Limerick Generating Station, Units 1 and 2
Facility Operating License Nos. NPF-39 and NPF-85
NRC Docket Nos. 50-352 and 50-353

Subject: Response to Request for Additional Information Concerning Relief
Requests Associated with the Second Inservice Inspection (ISI) Interval

**Response to Request for Additional Information
Regarding Relief Requests Associated With the
Second Inservice Inspection Interval**

Limerick Generating Station, Units 1 and 2

Limerick 1
RECIRCULATION INLET
N2A

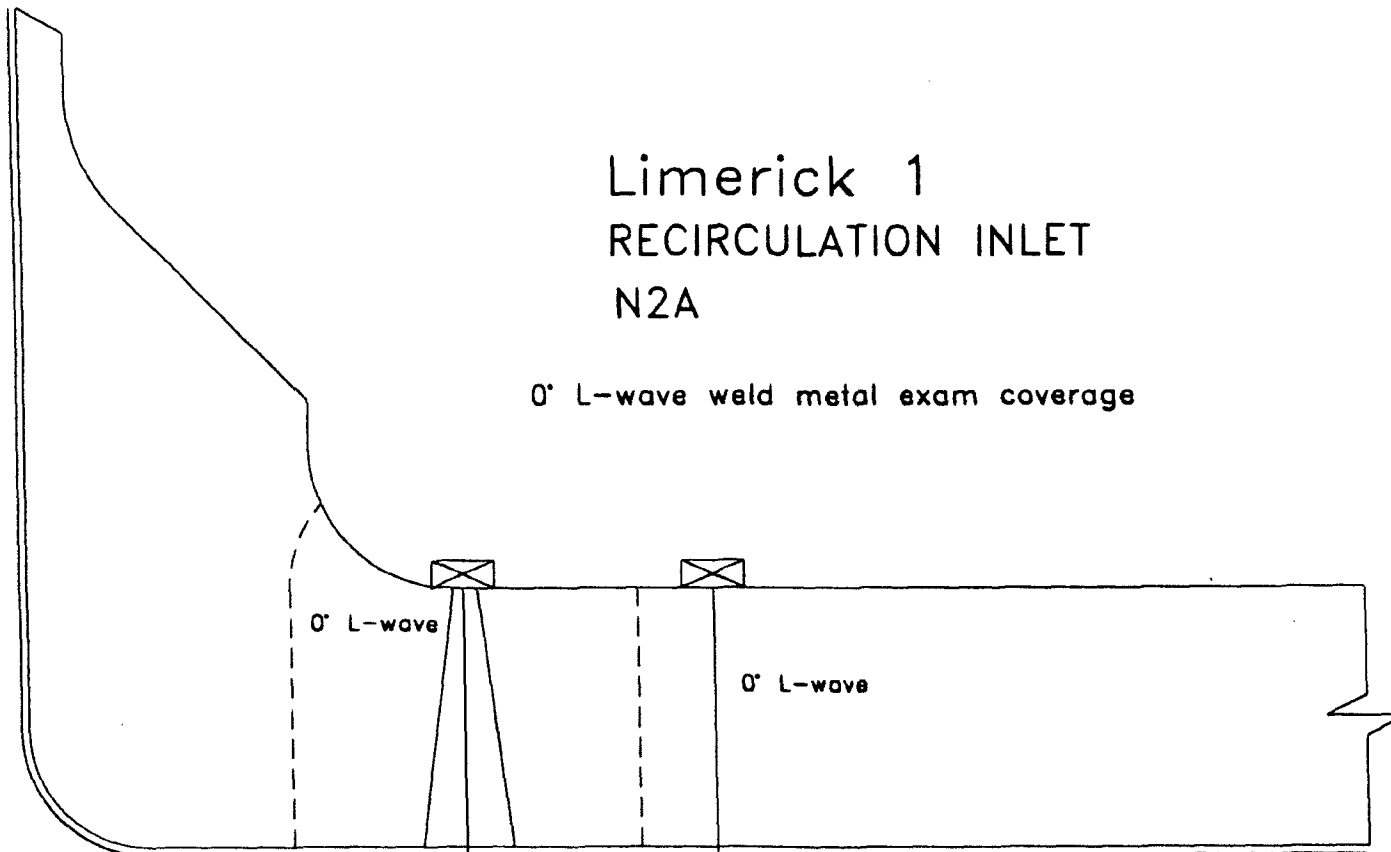
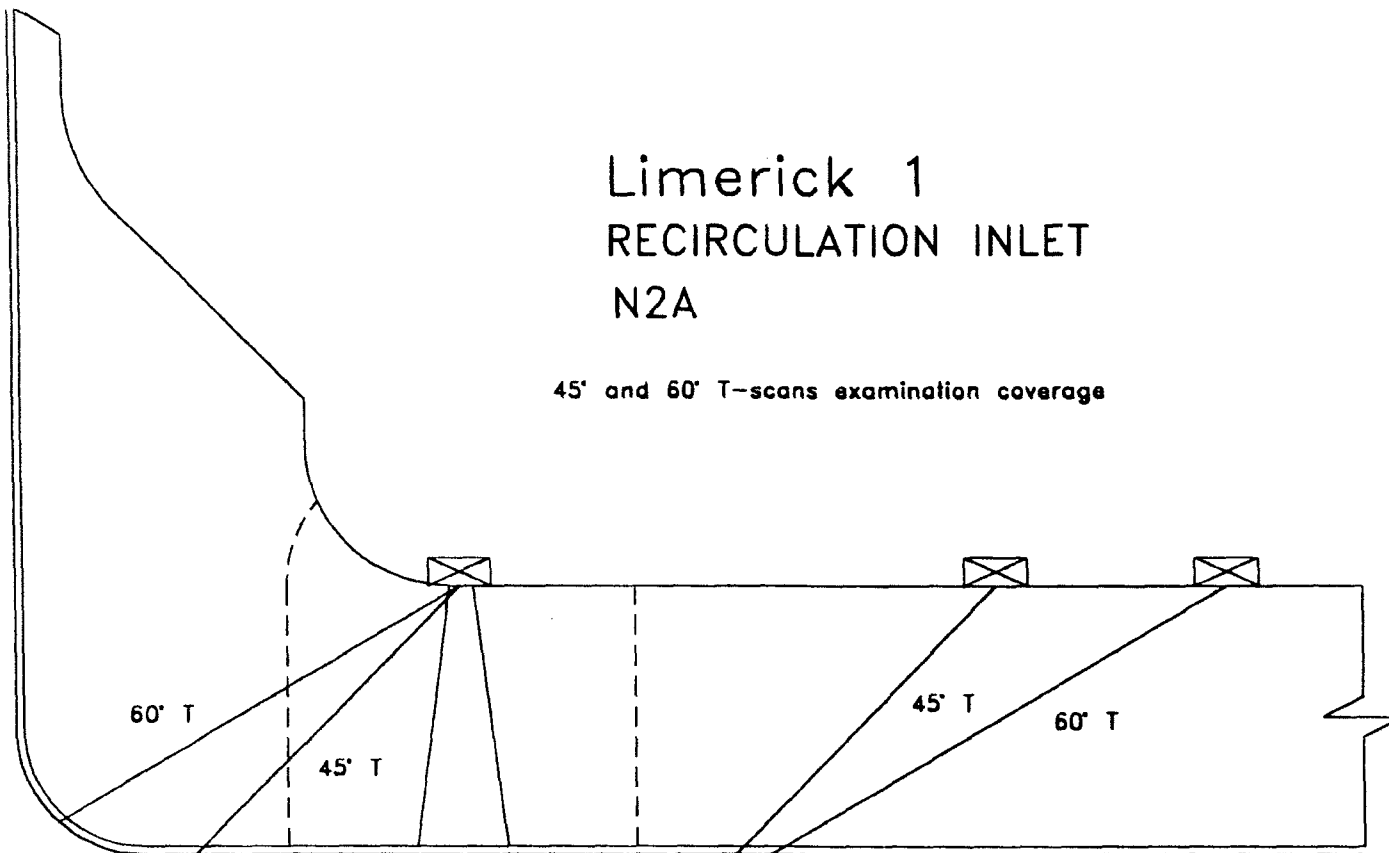
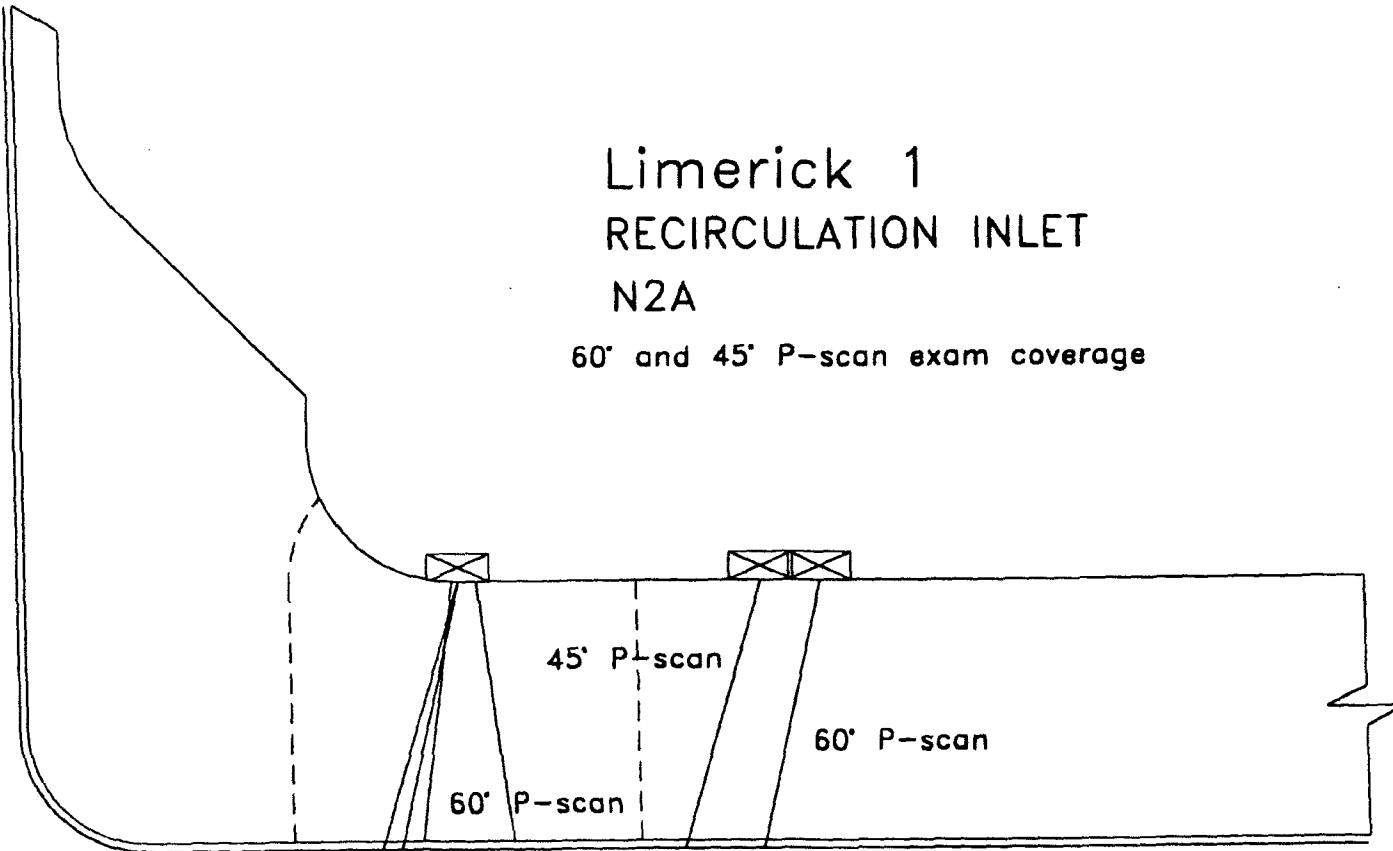
The completed examination was limited to 61.9% Code required coverage due to the design of the reactor vessel nozzle. The following coverage calculation sheet and the drawings contain the limitations. No unacceptable indications were noted. A system pressure test was also completed with no unacceptable indications observed.

Limerick 1 RECIRCULATION INLET N2D

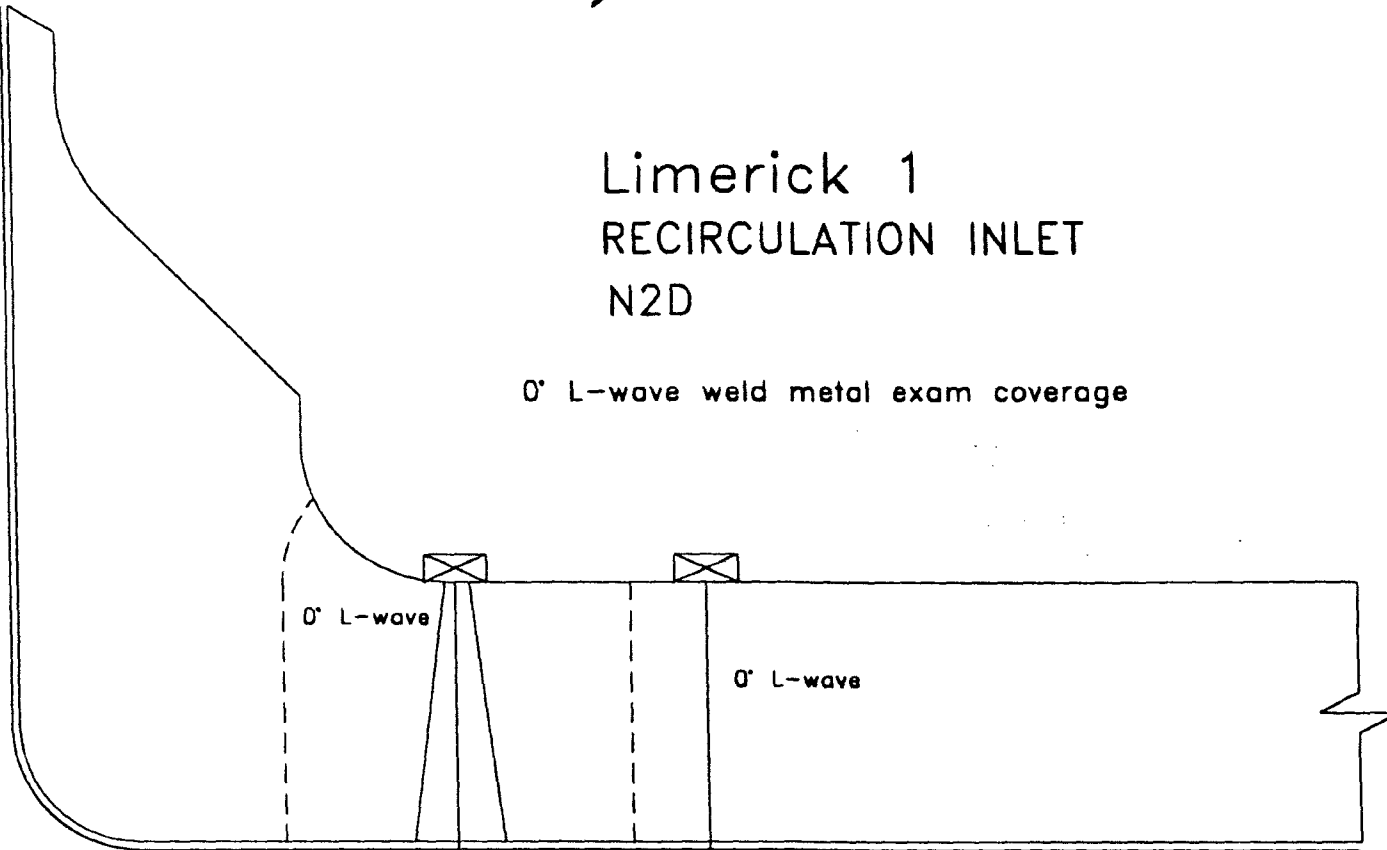
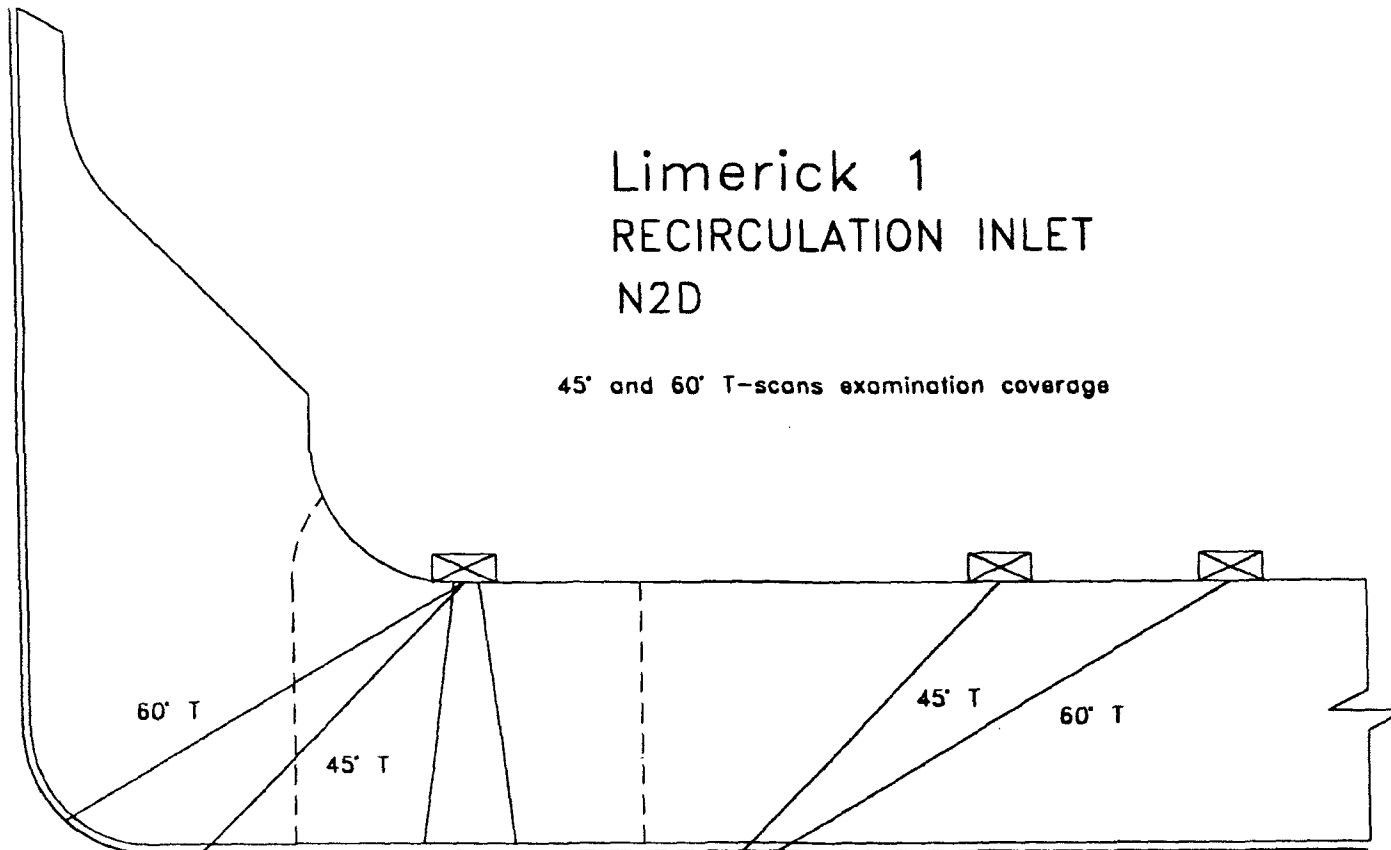
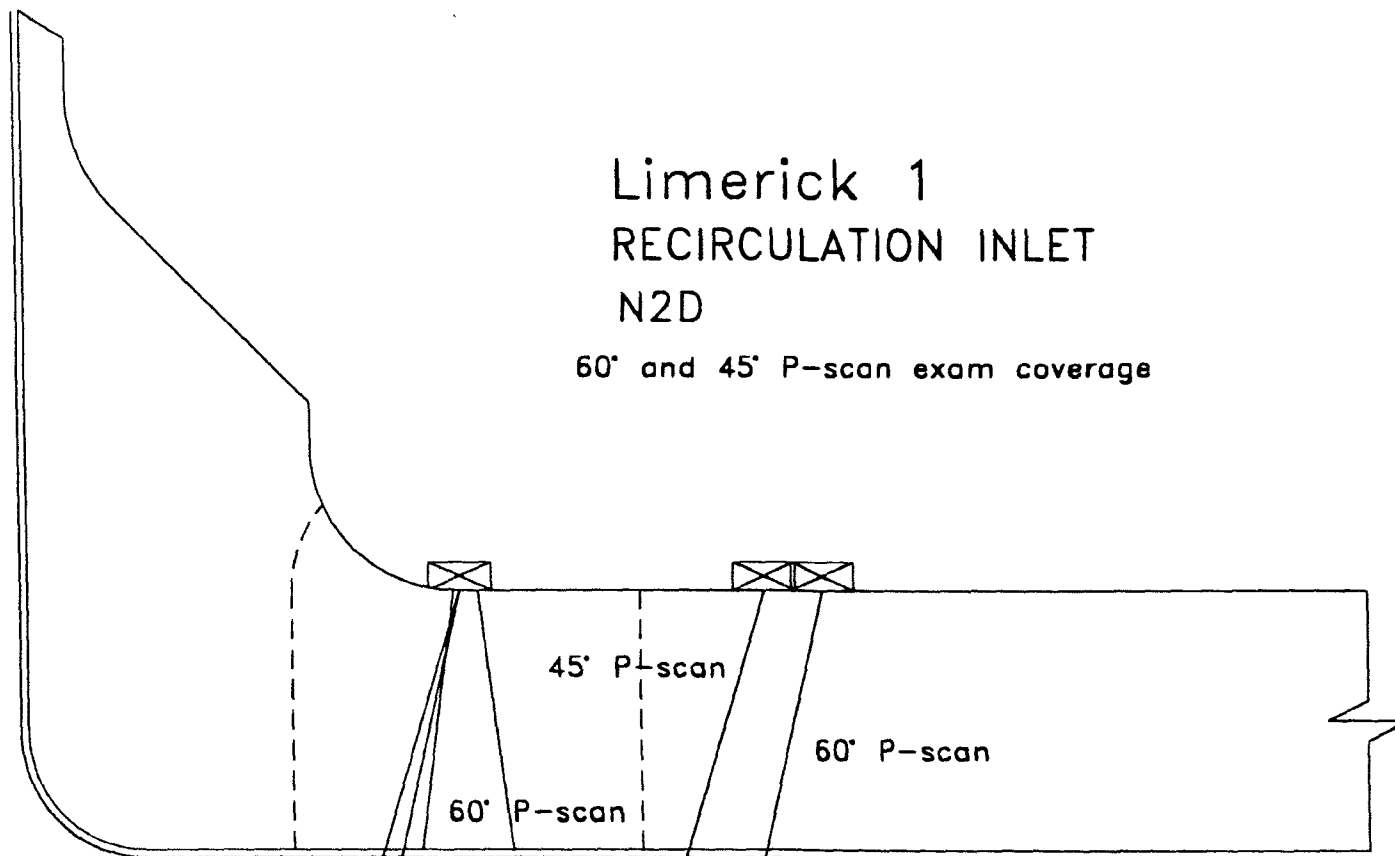
The completed examination was limited to 61.9% Code required coverage due to the design of the reactor vessel nozzle and the location of the N8A nozzle. The following coverage calculation sheet and the drawings contain the limitations. No unacceptable indications were noted. A system pressure test was also completed with no unacceptable indications observed.

Limerick 1 RECIRCULATION INLET N2F

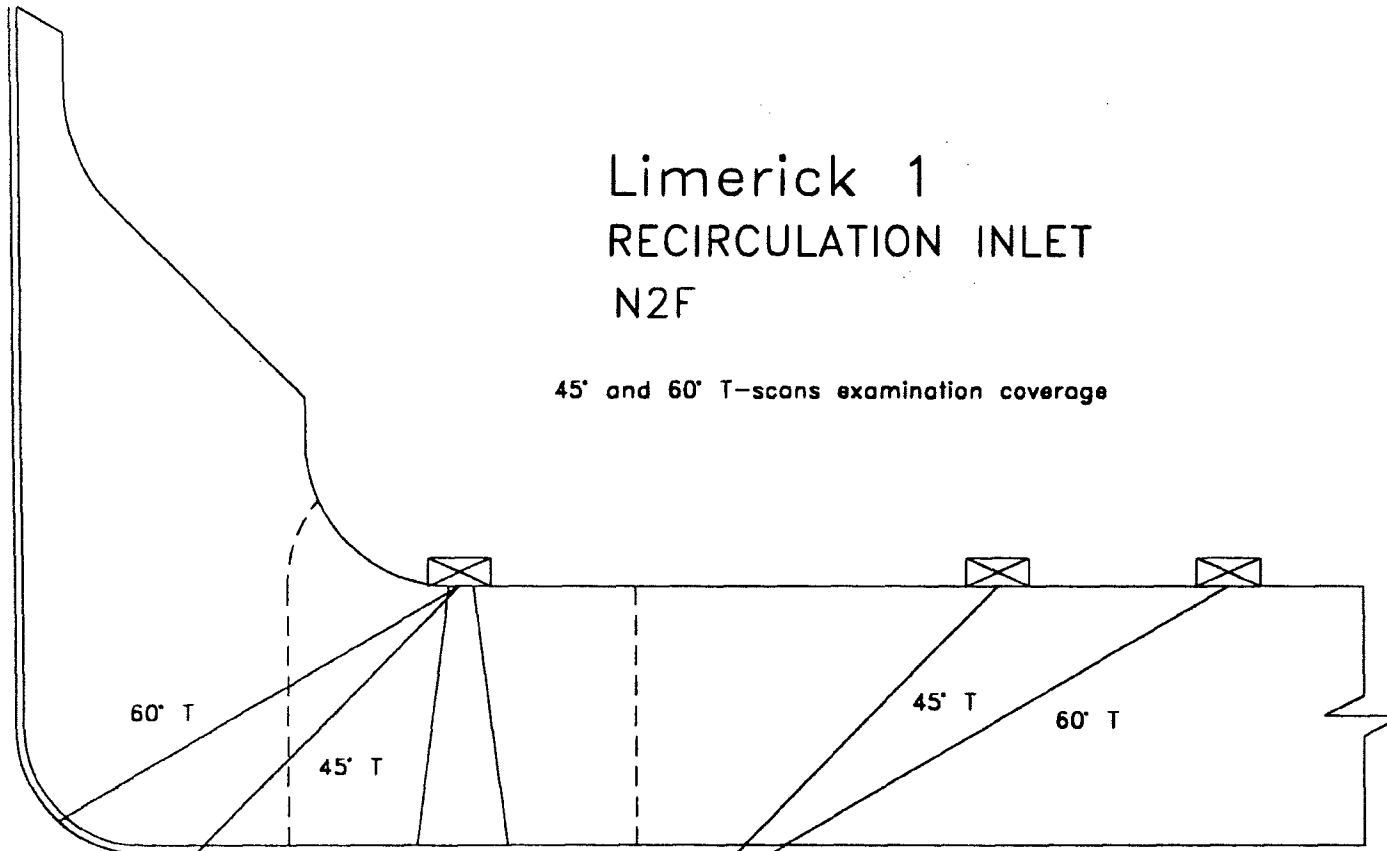
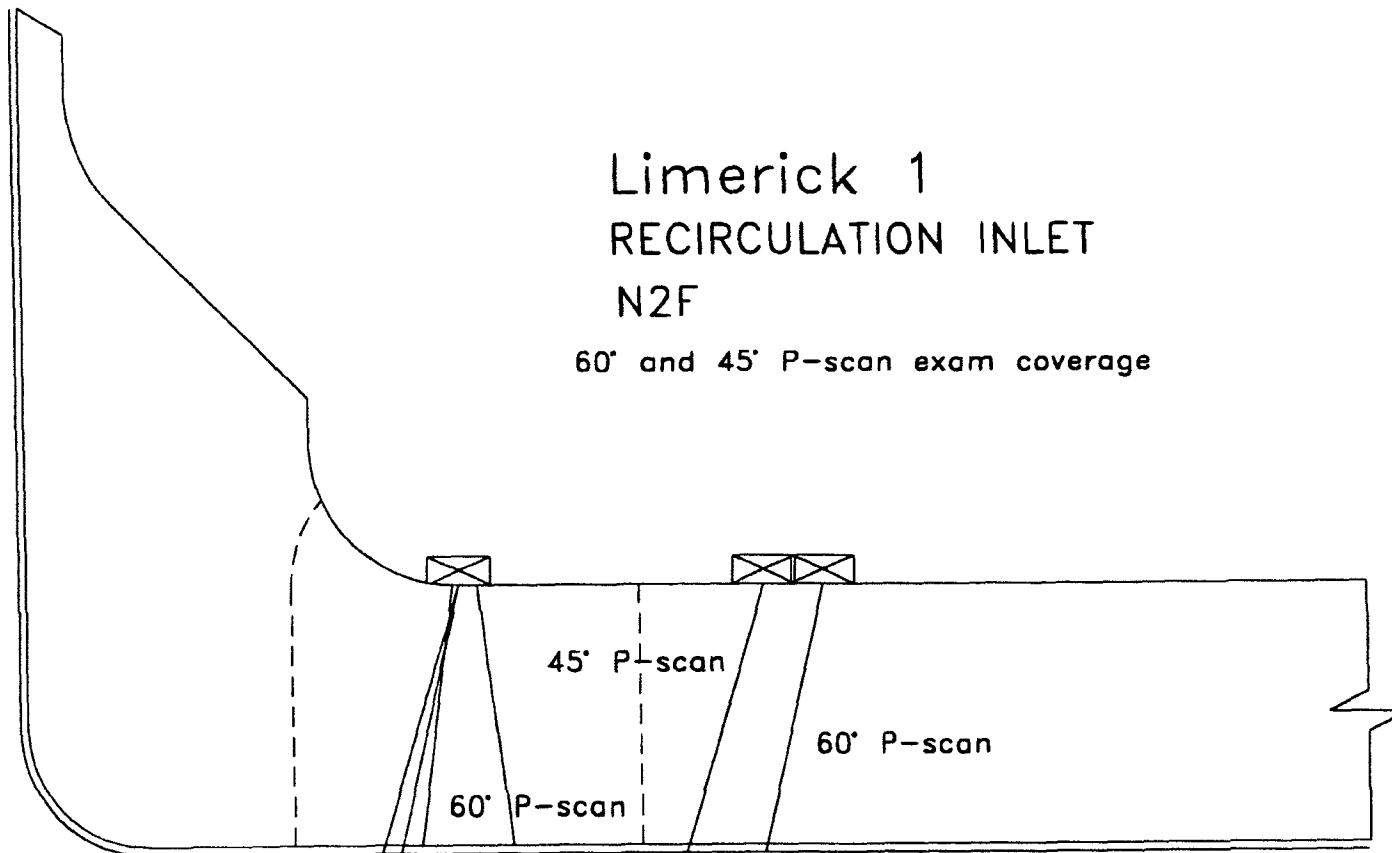
The completed examination was limited to 61.9% Code required coverage due to the design of the reactor vessel nozzle. The following coverage calculation sheet and the drawings contain the limitations. No unacceptable indications were noted. A system pressure test was also completed with no unacceptable indications observed.
